Client File No. 5719.00
Licence No. 3207

RE: Notice of Alteration for the St. Vital Transmission Complex Project

Figure 1: Shelterbelt on current alignment

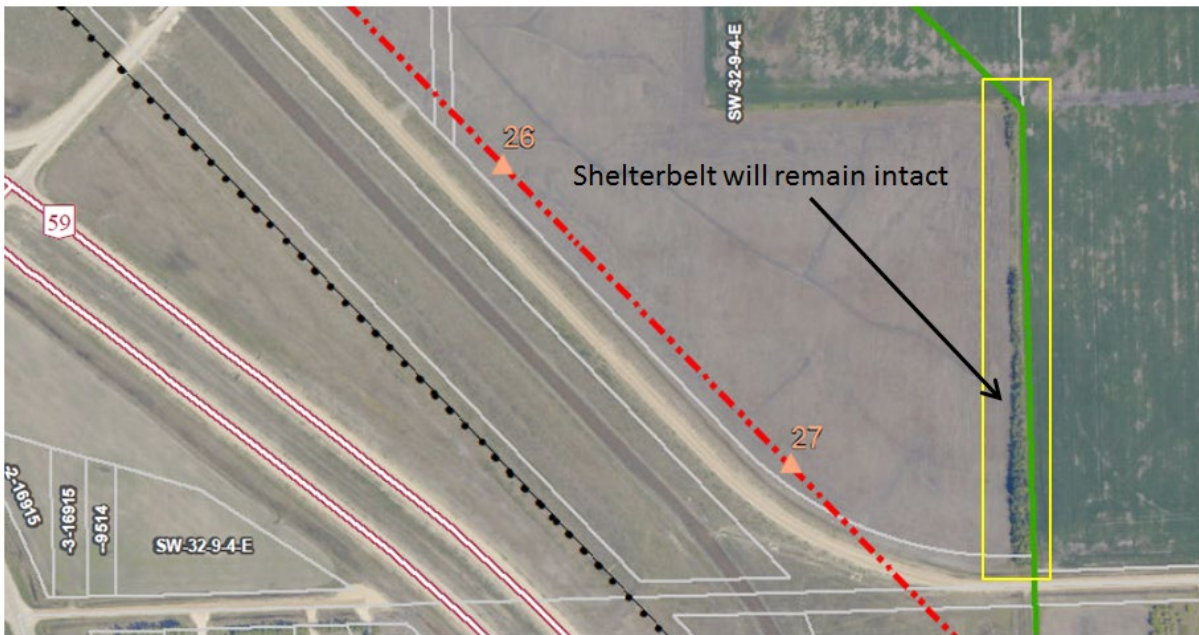
Changes to the potential effects of the project relate primarily to the agricultural land use and wildlife valued components. These changes are summarized in table 1. The adjustment will result in a slightly smaller overall footprint on agricultural land and will result in the retention of a small shelterbelt (figure 1; photo 1),
